Transport Assessment Addendum

Land north of Balcombe Road,
Haywards Heath

April 2026

Roundabout Geometry

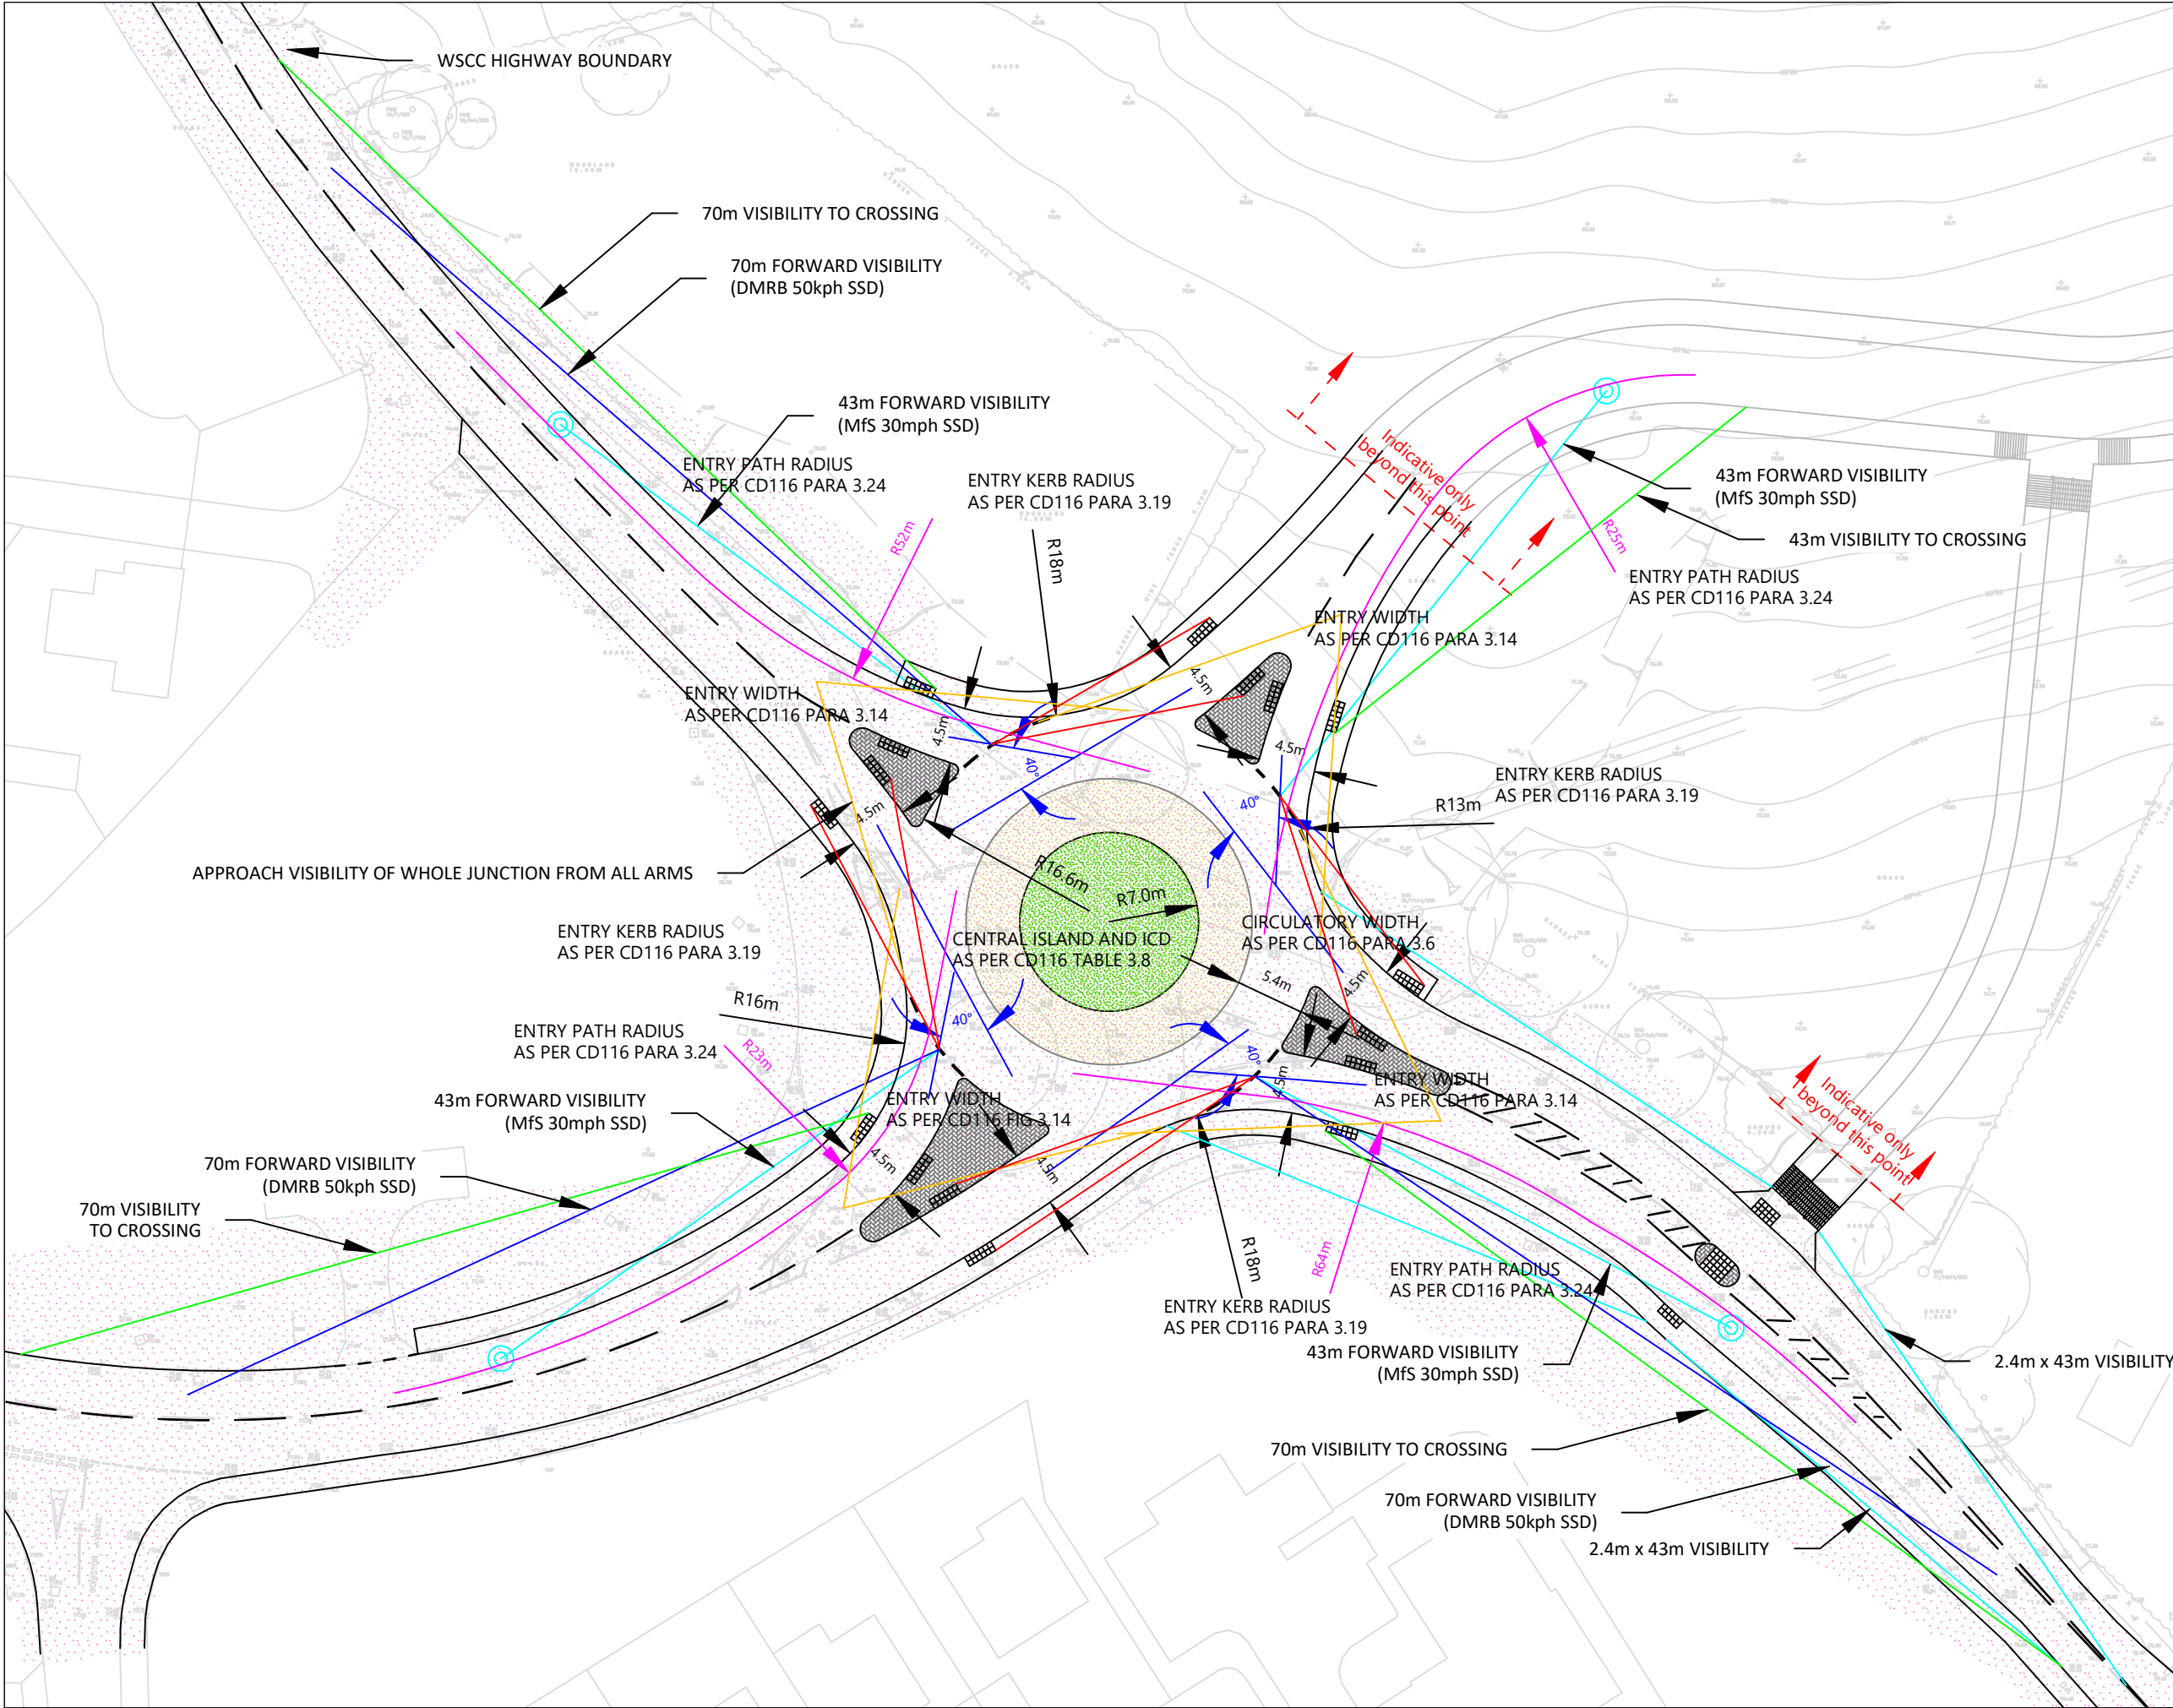
- 3.4.1 Page 2 of the WSCC response lists eight points requiring additional information relating to the roundabout. Responding to the points in turn:
- 1) The revised geometry and visibility splays (including pedestrian and cycle crossing points) are shown on Drawing 352 along with references to the relevant clauses in CD116 and associated documents.
 - 2) The compact roundabout now includes an over-runnable area intended to be used by large vehicles such as buses and articulated lorries. Swept path vehicle tracking for vans, refuse vehicles, buses and 16.5m articulated vehicles are included on the revisions to the drawings.
 - 3) The proposed footway has been extended on the north side of the roundabout and a pedestrian crossing provided across the Borde Hill Lane arm of the roundabout. Full pedestrian crossing provision is therefore provided across all four arms of the roundabout.

- 3.2.5 Drawing SDP-XX-XX-DR-D-352/P5 provides details of the roundabout geometry and visibility to the give-way lines on all arms. A 43m forward visibility profile is shown, consistent with Manual for Streets requirements for 30mph vehicle speeds, as identified by the speed surveys. Details of the speed survey methodology is included in Appendix B. Forward visibility profiles of 70m, consistent with DMRB requirements, are also shown along the main approaches.
